Subject: Contract No. 200-2004-03805, Task Order 1: Draft Review of the  
NIOSH Site Profile for the Idaho National Laboratory, Idaho – Revision 1

**Review of the NIOSH Site Profile for the  
Idaho National Laboratory, Idaho**

**SCA-TR-TASK1-0005**

#### 5.1.4.1.11 Minimum Detection Limit

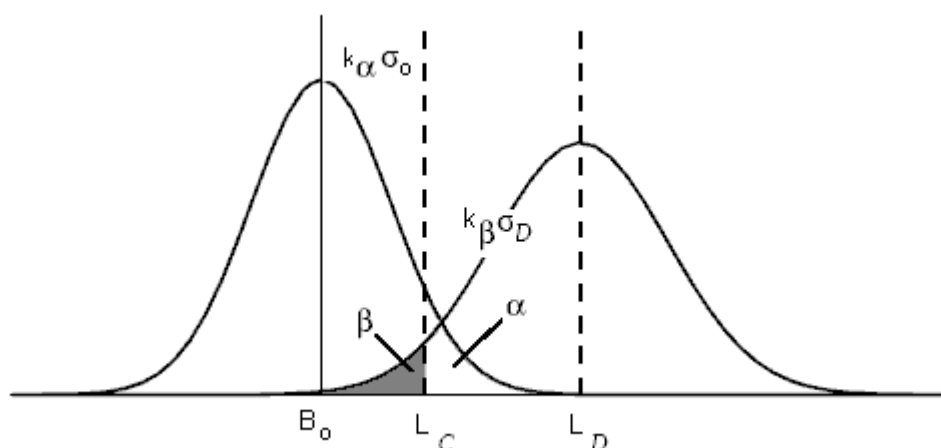
Determination of the minimum detection limit (MDL) takes the dosimetry system uncertainty into consideration. The mathematics of this process is discussed in the External Dose TBD. When using state-of-the-art dosimetry systems today, with a 20 mrem (0.02 mSv) MDL, there will be a number of "false positive" results. As stated in the TBD (pp. 13–15), the necessary information to determine the MDL is not given in the NRTS file, but a value of 30 mrem chosen

Unfortunately, the values cited for the 10, 20, and 30 mrem irradiations may not be used to estimate  $\sigma_0$ . For this calculation, approximately 20 or more non-irradiated monitors should be evaluated. The standard deviation of the optical densities may be used and then converted to a standard deviation in dose by multiplying by the optical density-to-dose coefficient for high-energy photons. This coefficient, from figure 1 of the report, is about  $10/0.02 = 500$  mrem per optical density unit. The  $L_D$  may then be calculated by multiplying the standard deviation in dose by 3.4.
